PLANNING CONSULTATION RESPONSE

Application No	2026/0640
Proposal	Residential development of 270 new dwellings, together with access, public open space, landscaping, drainage infrastructure and associated works
Address	Land south of Cemetery Road, Jump, Barnsley, S73 0QN
Date of Consultation Reply	
Consultee	Highways DC

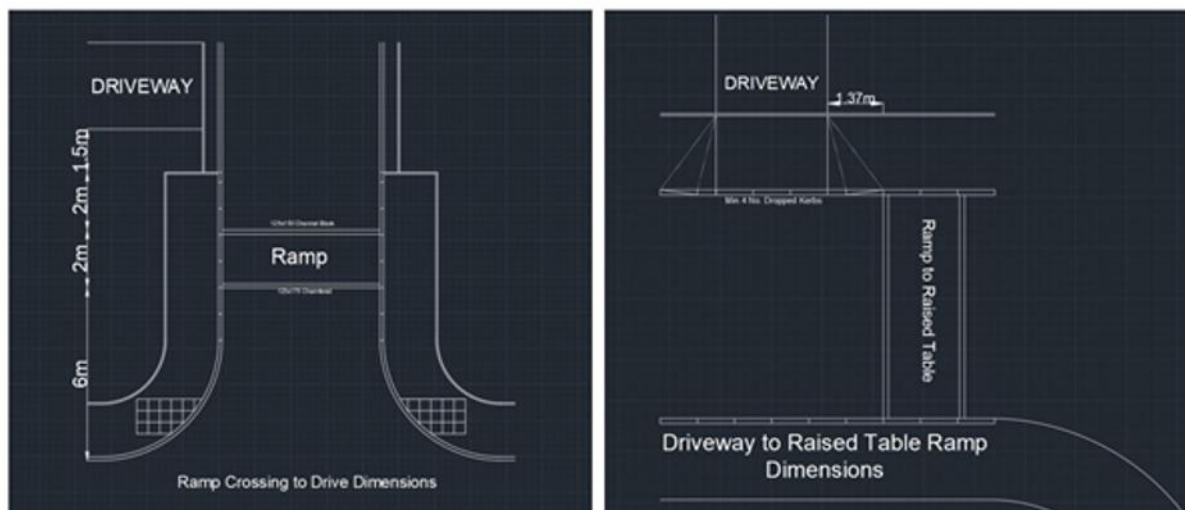
The Council's Section 38 engineers have made comment on the location and extents of some of the proposed tables. Many tables do not conform to the below design standards, and these should be followed:

Furthermore, there are lengths greater than 100m with no vertical or horizontal deflection. Individual speed controlling features for following the design speeds are required at these spacings: 20mph – 70 metres or if less than 20mph – 40 metres. This is cited in the SYRDG Appendix B Section 4. There is a table on the bend in front of plots 133-135 where the bend itself would serve as a speed-reducing feature; this vertical deflection would be better provided on the long, straight sections of estate road.
